TOWN OF ERIE
PLANNING COMMISSION AGENDA ITEM
June 4, 2025

SUBJECT: **PUBLIC HEARING: North Westerly PD Zoning**

A Resolution of the Planning Commission of the Town of Erie
Recommending that the Town Council Approve the North Westerly
Planned Development Zoning with Conditions

Town of Erie Zoning Map, subject property shown with black outline

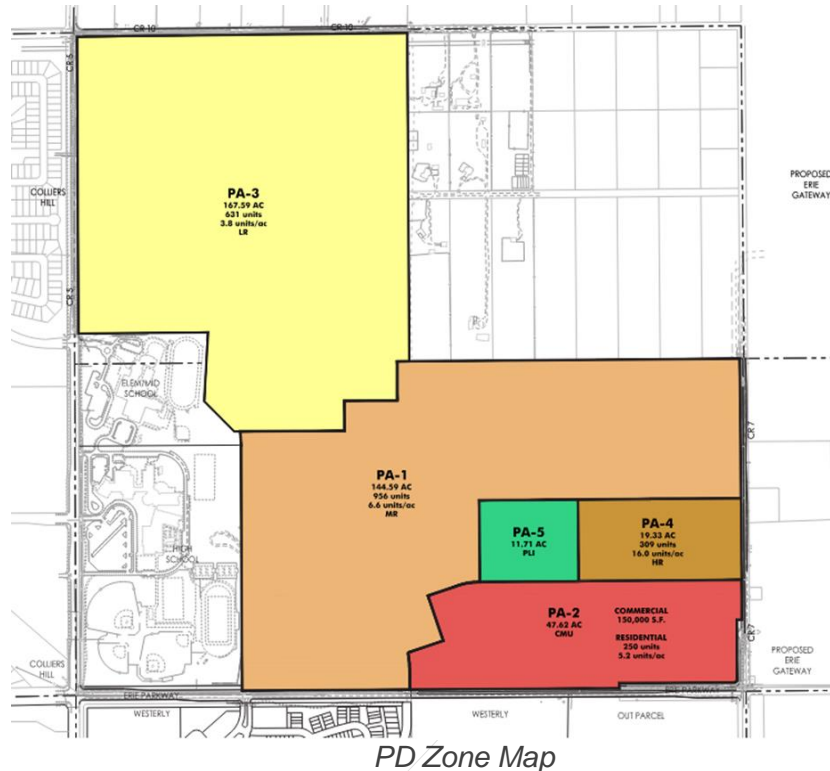
The subject property is currently zoned Low Density Residential (LR), Medium Density Residential (MR), High Density Residential (HR), and Community Commercial (CC).

The proposed Planned Development has underlying zone districts of Low Density Residential (LR) in the northwest, Medium Density Residential (MR) adjacent the schools and northeast, High Density Residential (HR) along the east, Community Mixed Use (CMU) in the southeast, and Public Land and Institutional (PLI) at the center of the neighborhood.

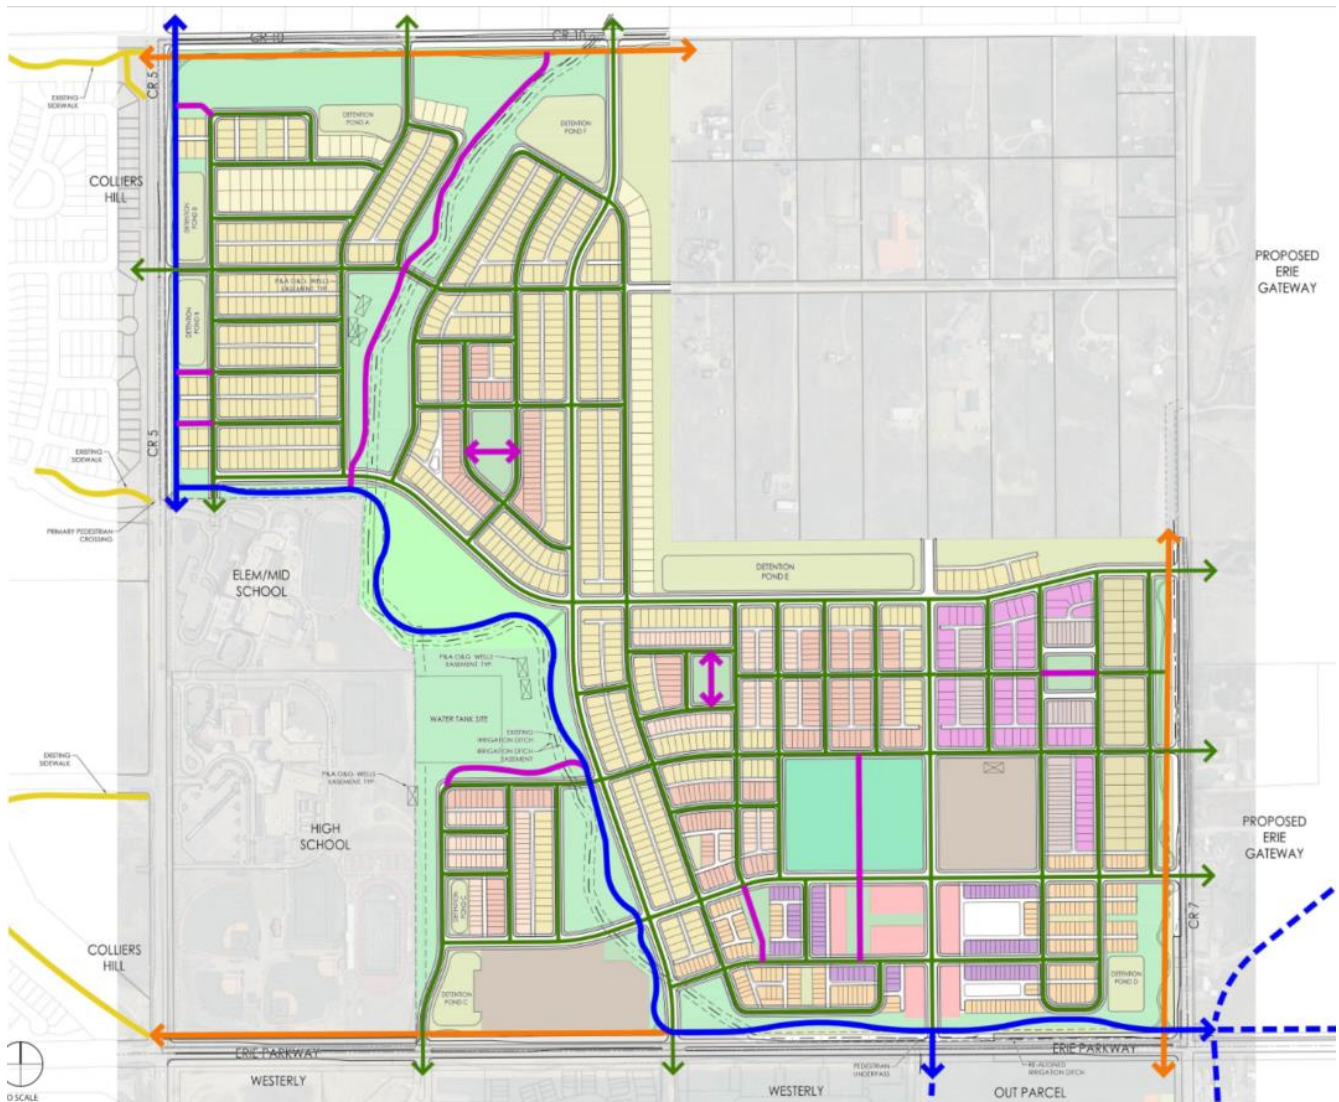
The Streetscape Plan is generally consistent with the Transportation Mobility Plan (TMP). The Pre-Development Agreement specified major through north-south and east-west connections that are met with the Planned Development Streetscape Plan. Street classifications are indicated on the Streetscape Plan below. Specific street sections shall conform to the Town Standards & Specifications and will be reviewed at plat.

- Erie Parkway from CR5 to CR7 – developer shall be responsible for constructing entirety in a single phase, final design to be determined at Final Plat
- CR7 – developer shall construct the west half along the property line per the TMP, final design to be determined at Final Plat

- Flora View –planned as the major east-west connection shown as a Major Collector with median and designated bikeway
- Waterford –planned as the major north-south connection shown as a Major Collector with median and designated bikeway
- East-West Minor Collector – planned east-west minor collector with designated bikeway adjacent multi-family, community amenity, and commercial
- North-South “Main Street” – planned North-South roadway with a designated bikeway. Roadway designation will be a minor collector north of the planned Community Amenity and to the South (connection with Erie Parkway), will be determined with future traffic studies at plat in conjunction further clarification of the commercial property uses.

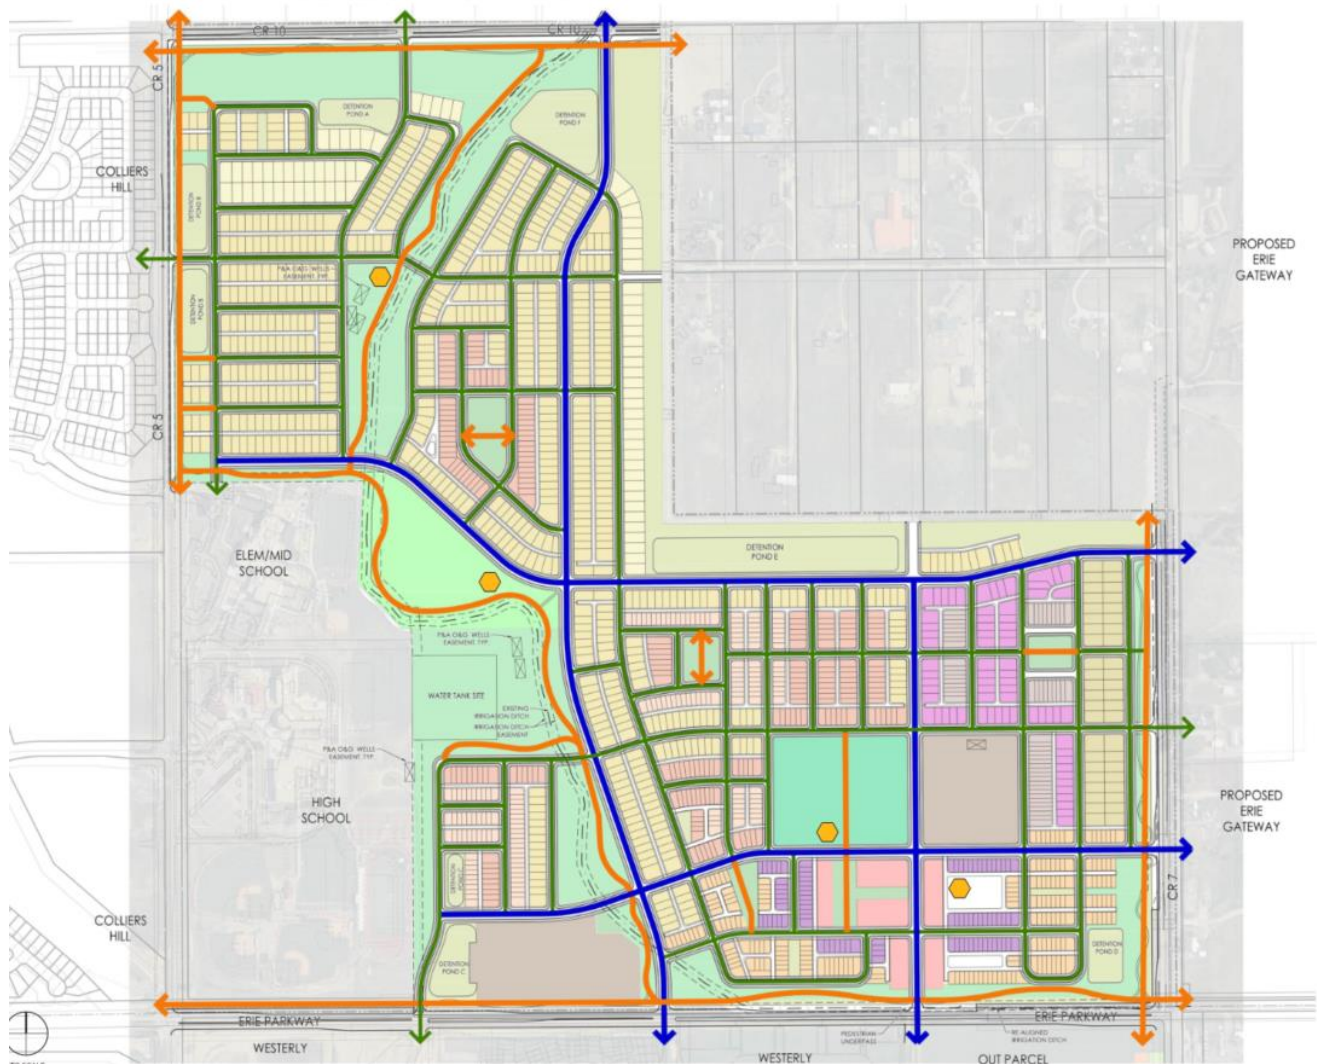
The Bicycle Connectivity Plan is consistent with the Transportation Mobility Plan (TMP). There are proposed on-street bike facilities on the collector streets. There are proposed shared mobility amenities (i.e. B-cycle, scooters, and/or car sharing) located at key destinations in response to requests by the Sustainability Division.
